Attachment 9
NRC3-12-0003
(17 pages)

Response to RAI Letter No. 70
(eRAI Tracking No. 6244)

RAI Question No. 03.07.01-7

Figure 2: RB/FB horizontal estimated 2% damped FIRS compared to the 2% damped spectrum for the RB/FB H1 SSI time history.

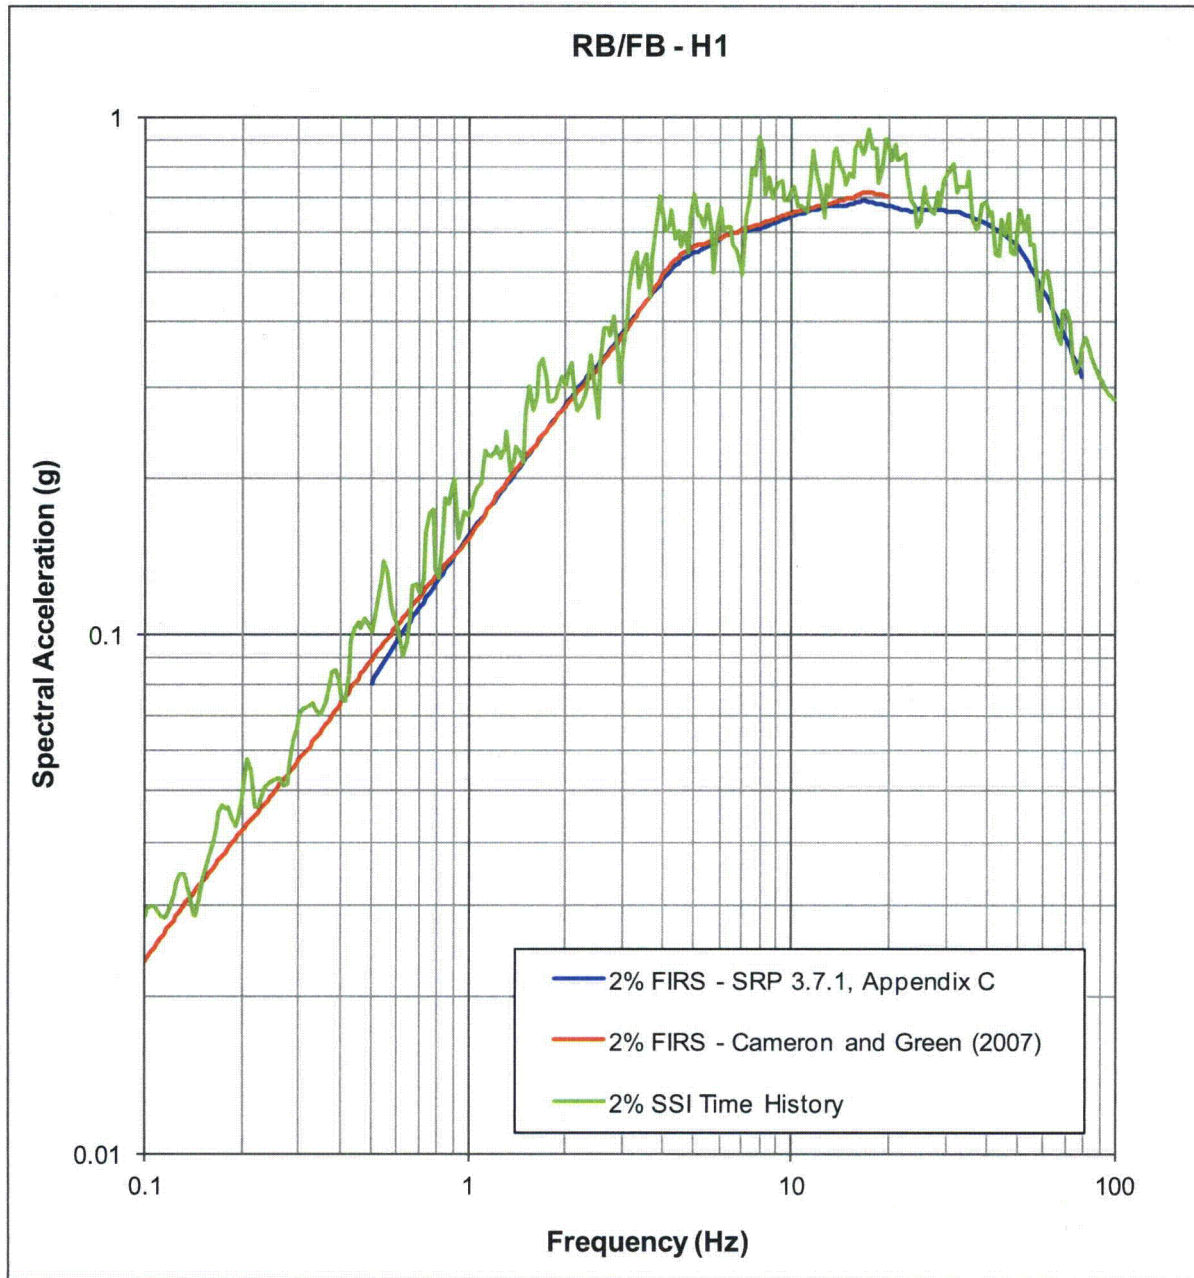
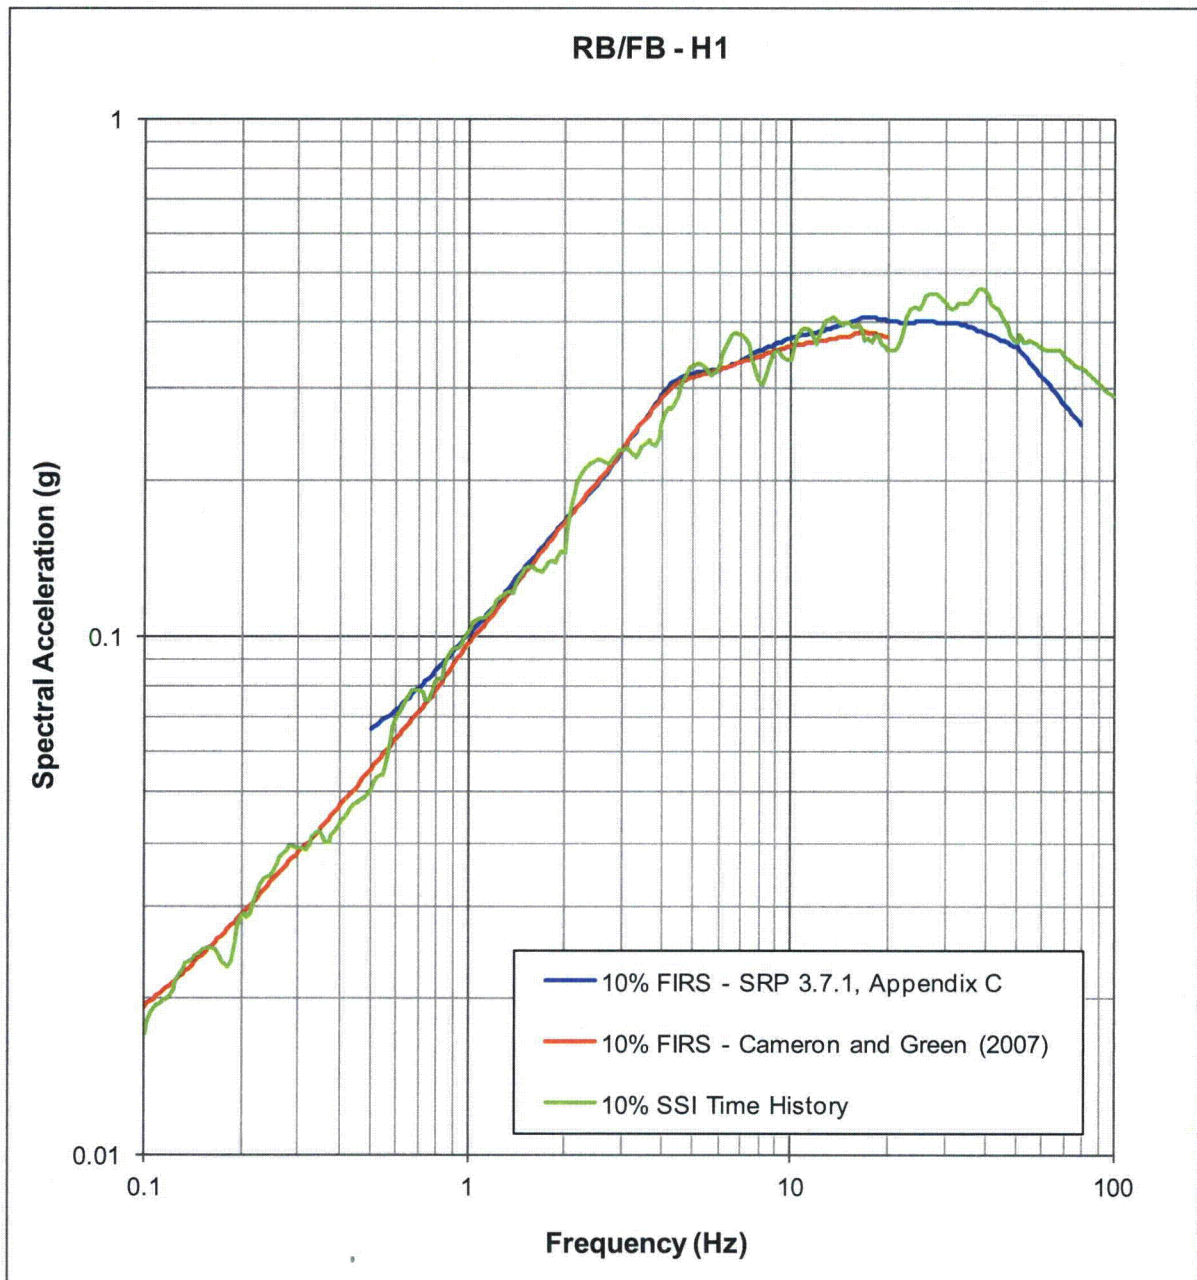
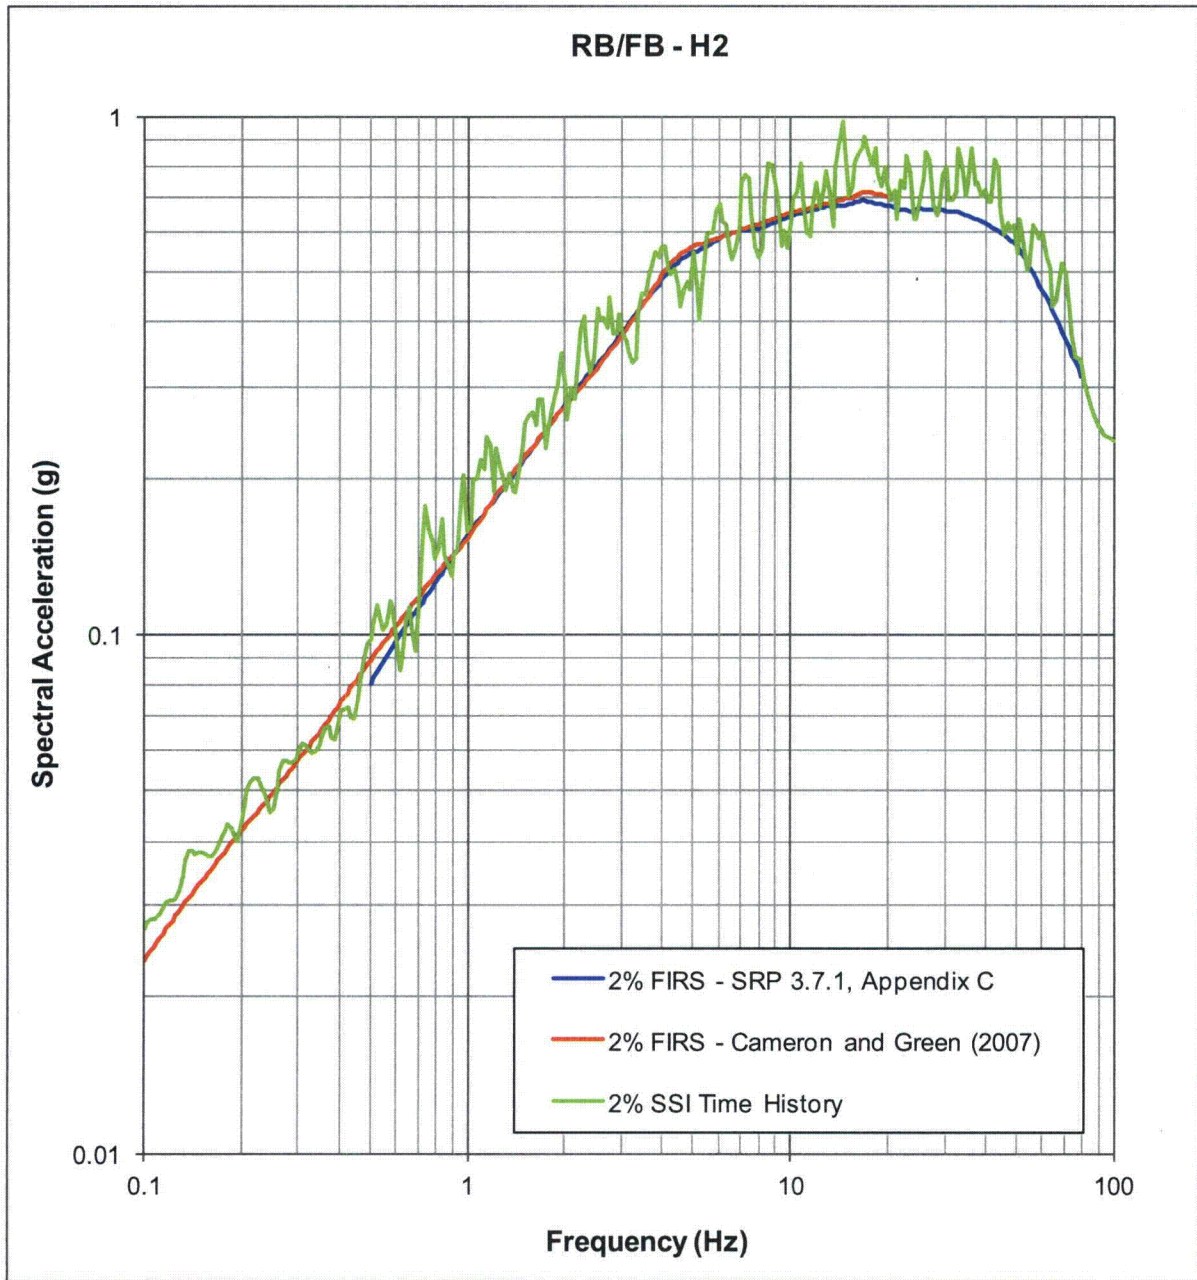
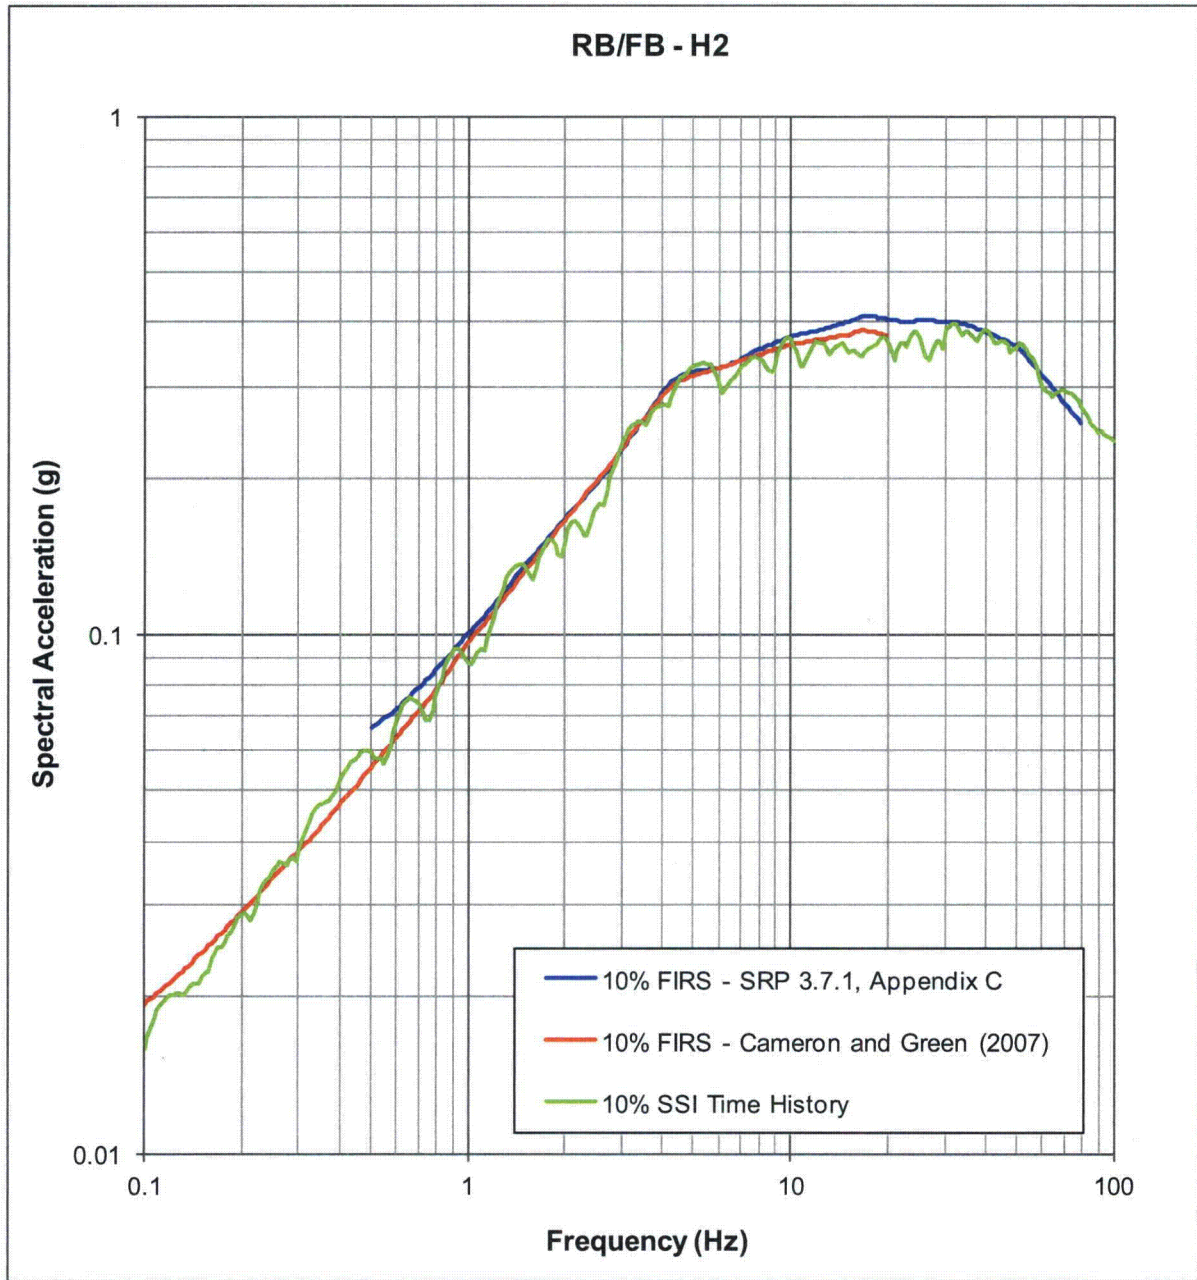
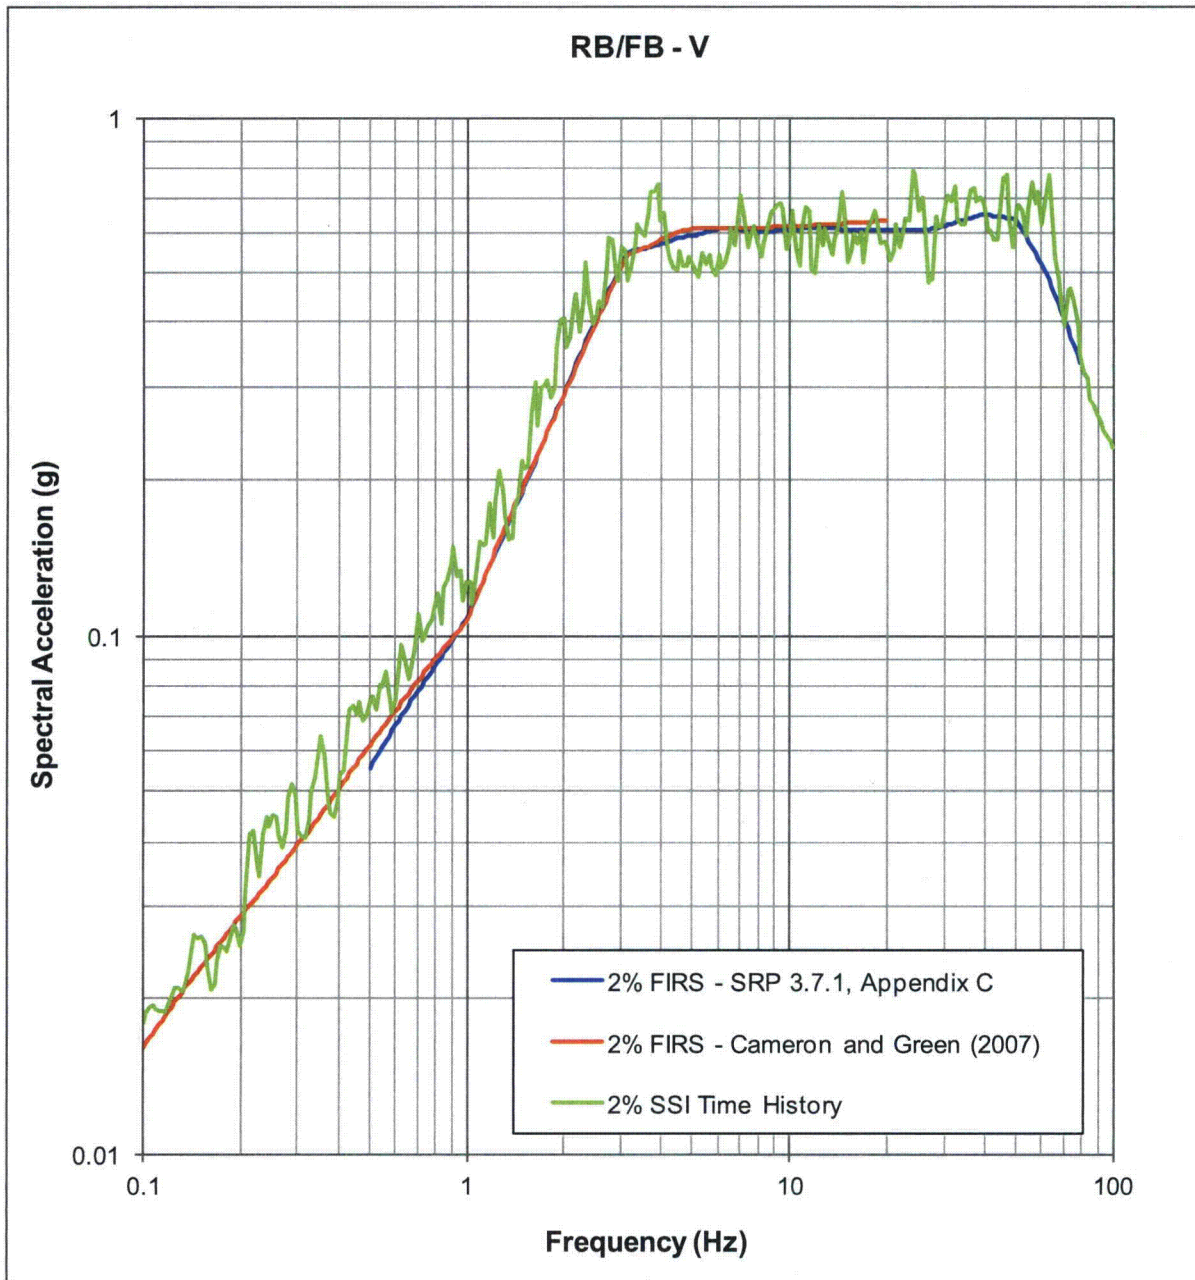
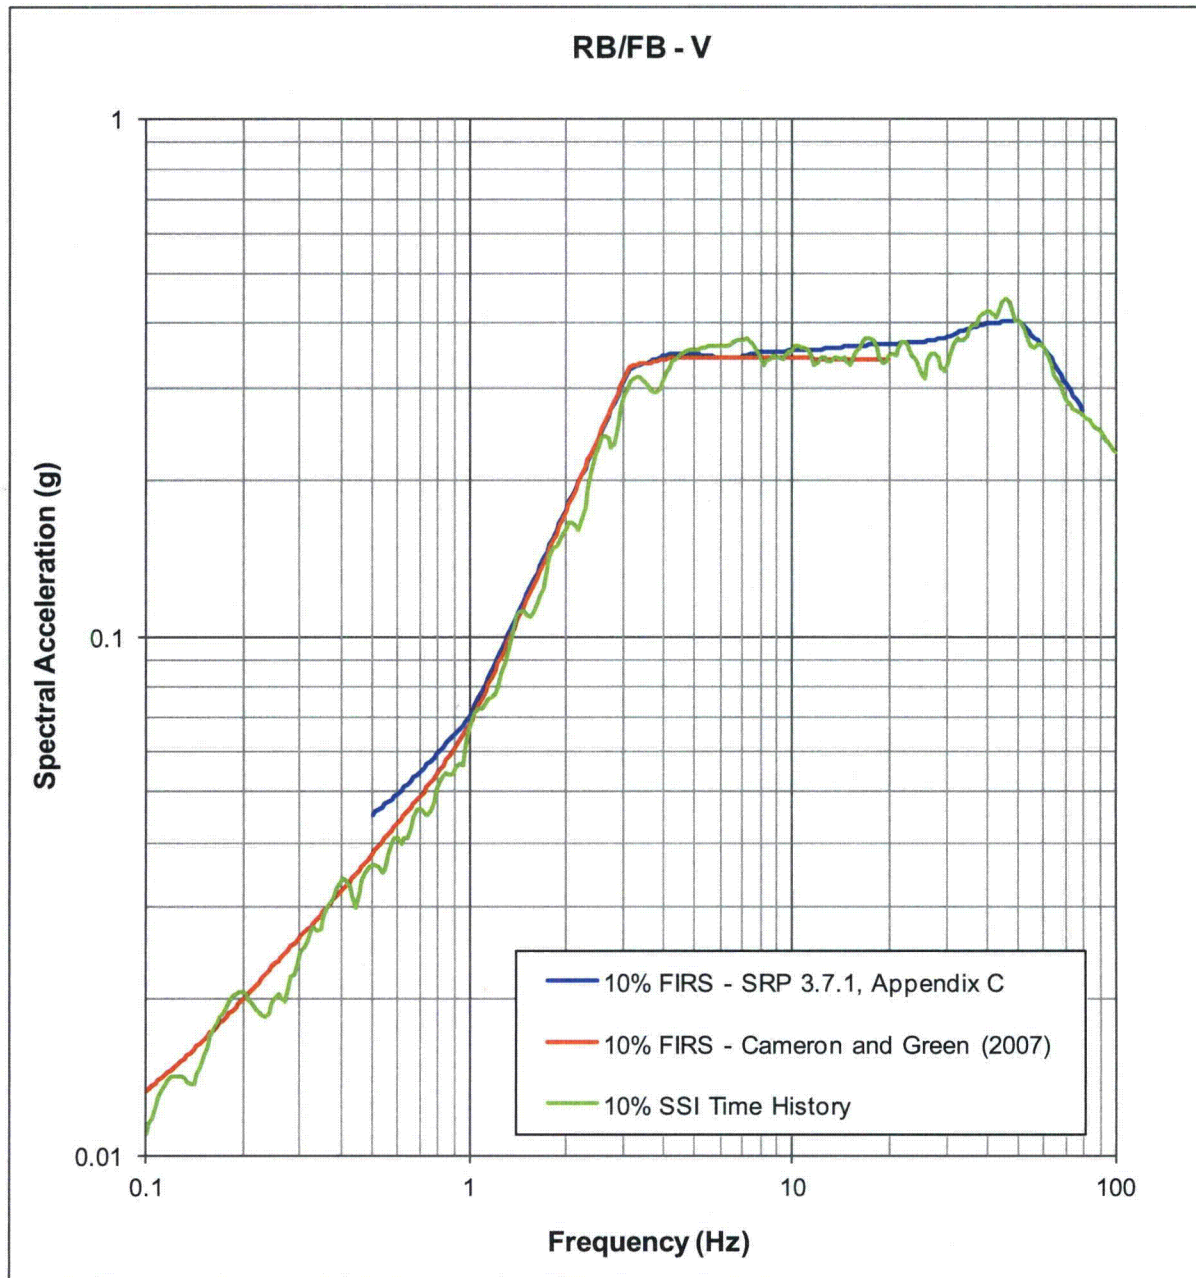
SRP Acceptance Criteria 3.7.1.II.1B also specifies that PGV/PGA should be consistent with the characteristic values for the controlling earthquake. As such, the applicant is requested to provide further justification of the acceptability of the PGV/PGA values for the artificial time histories being higher than the selected controlling earthquake. The applicant is also requested to provide comparison of the response spectra of the artificial time histories and the estimated target spectra (SSI FIRS) at 2 percent and 10 percent damping values for RB/FB and CB.

Figures 2 through 13 show the RB/FB and CB SSI FIRS scaled to 2 percent damping and 10 percent damping. Shown on each of the plots is the corresponding 2 percent or 10 percent damped spectrum for an individual SSI time history. The time history spectra are in good agreement with the scaled FIRS.
